E3939A/B-02-S

S E R V I C E N O T E

HP E3939A/B PT500 Protocol Tester

PT BACK BEZEL GROUNDING WIRES UPGRADE

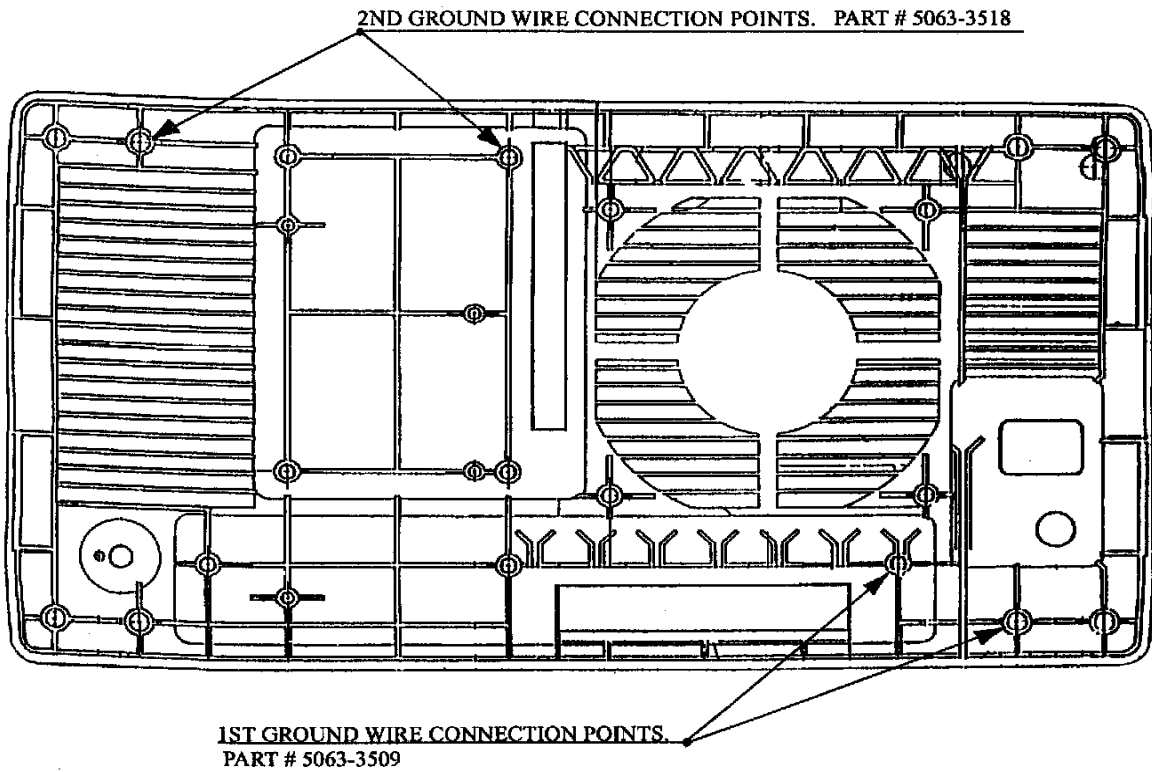
A situation exists in which a unit in the referenced serial number range could possibly become a shock hazard to personnel. This situation would likely only occur if high voltage is present on the connector module plane or connector module handle and the existing ground path was blown away. The existing ground path is insufficient to carry current specified by Hewlett-Packard safety requirements. This situation has occurred to date only when checking the unit with a megger or similar device.

Affected units must be retrofitted with grounding wires to rectify the problem, using the following instructions.

- Remove top cover of instrument and interface module.
- Install longer (11 cm) ground cable, p/n 5063-3518, to existing screw of upper left hand side member bracket hole.
- Connect to inside connector module hole, beside degaussing board, with 4x5 screw.

- Remove bottom cover of instrument and auxilliary connector module.
- Install 8 cm ground cable, p/n 5063-3509, to right hand side hole of auxilliary connector with 4x5 screw.

- Connector module handle should be grounded from the rear handle screw to the nearest DB style connector screw by installing one of the 5063-3510 wires between these two points.
- Use the four 4x28 screws to reinstall connector module.

- Applies only to MPT368.2, IPT468, XPE systems with no parallel printer connector, that is, with auxilliary connector module 4010-0070-IDA.
- Install grounding wire between the handle mounting screw and the nearest screw of the "PRINTER" connector.
- Reinstall auxilliary connector module using three 4x25 screws.
